**TOWN OF HERNDON, VIRGINIA
HISTORIC DISTRICT REVIEW BOARD
VIRTUAL PUBLIC HEARING AGENDA
MAY 19, 2021
HERNDON COUNCIL CHAMBERS BUILDING
765 LYNN STREET
7:00 P.M.**

Subject: HDRB #21-008, 764 Grace St. Addition Update

Resolution- to consider HDRB #21-008, 764 Grace Street, a Certificate of Appropriateness to allow the construction of a one-and-one half story addition to a contributing structure.

RE: COA Application for Addition at 764 Grace Street

764 Grace Street Addition –Deck Parapet/Railing Concept

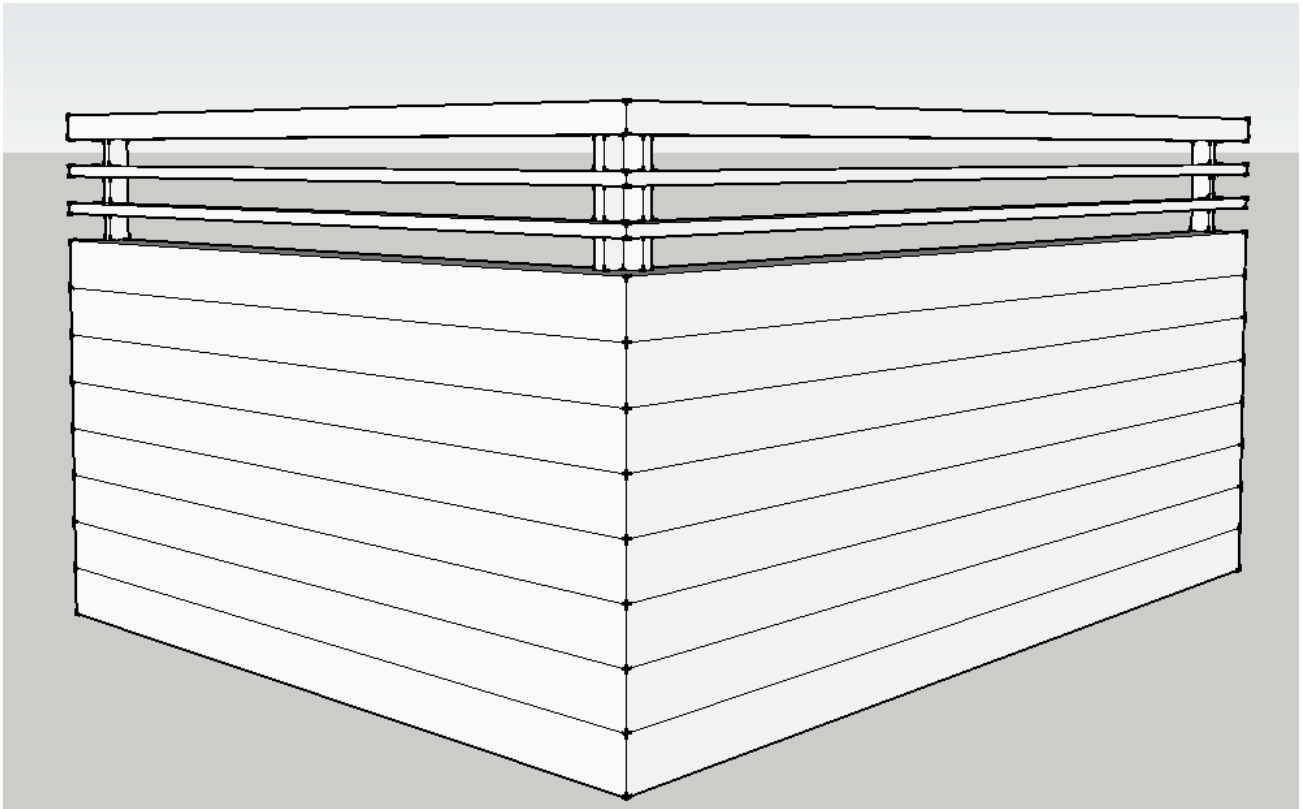
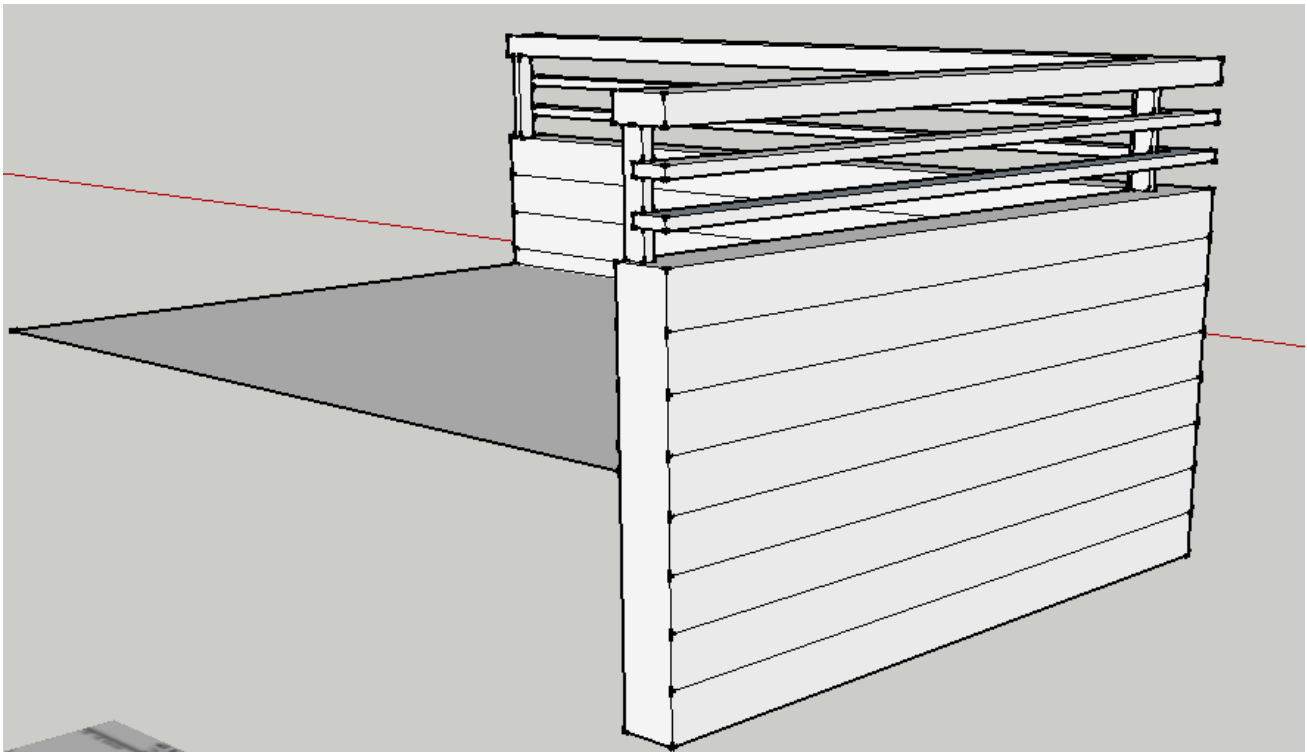
In his letter dated May 13, 2021 (Attachment #2), the applicant expresses his appreciation for the guidance provided by the HDRB during the May 5, 2021 work session. Furthermore, he explains the rationale for the proposed revision to the parapet design, as demonstrated in the revised drawings (Attachment #3). Photographs of various roof deck parapets (Attachment #4) are also provided. The photographs contain designs used by the applicant and his architect to develop the currently proposed concept. The intent of the revision is to continue the horizontality of the siding and the simple modern aesthetic while reducing the mass and scale of the parapet wall. The applicant is requesting that the HDRB approve the design of the parapet but permit some flexibility to allow further refinement.

The revised elevation drawings correct the minor inconsistencies that existed between them and the perspective renderings and show a new parapet wall design around the roof deck. The new design includes solid wall topped with an open horizontal-oriented railing. Many options were considered but this design, we concluded, offered the best compromise between continuing the horizontal emphasis of the siding and maintain the simple modern aesthetic while also reducing the mass and scale of the parapet wall and adding some degree of openness. The images provided show a collection of roof decks that were used as inspiration for the design. Our preference is to be allowed some flexibility to work from this design but refine it with further staff review.

2. The applicant shall have the option of abutting the siding to the window jambs or returning the siding onto the jambs.
3. The applicant shall work with staff on final design details of the proposed parapet, which is to be in general conformity with the drawings and images submitted on May 13, 2021.

Siding at Wall Openings – Design Options

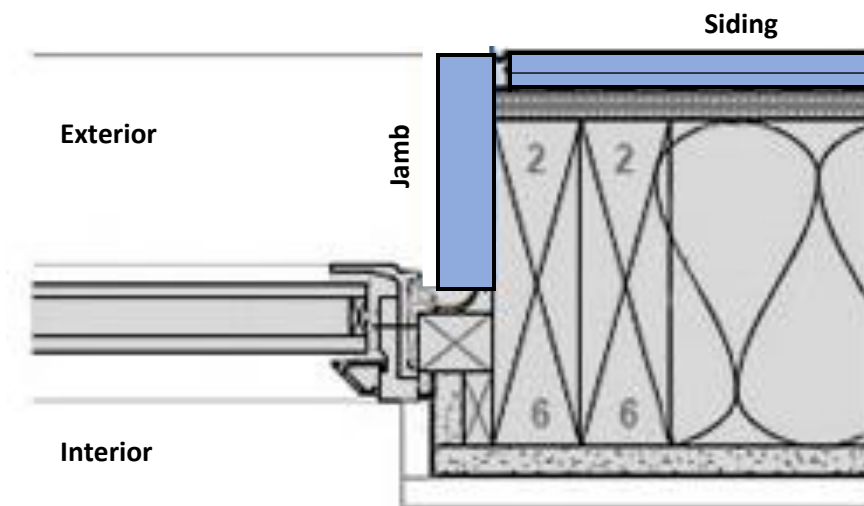
The window options (Attachment #5) consist of extending open jamb boards to be flush with the siding and allowing the siding to abut the board edge, or having mitered siding wrap the jambs and returns to the window frame. The photographs provided by the applicant clearly demonstrate the visual difference between the two approaches. While the applicant currently prefers Option 1, the applicant is requesting the flexibility to utilize either option. Staff supports this request. While the staff prefers Option 2, as it minimizes the visibility of the bronze metal and displays only the window frame, both options 1 and 2 reflect the simplified contemporary design of the addition.

The additional wall opening information includes both construction details and precedent images. As of now, the preference is to abut the siding to the window jamb boards, shown as option 1, but we would like the flexibility of also possibly returning the siding onto the jambs, shown as option 2.
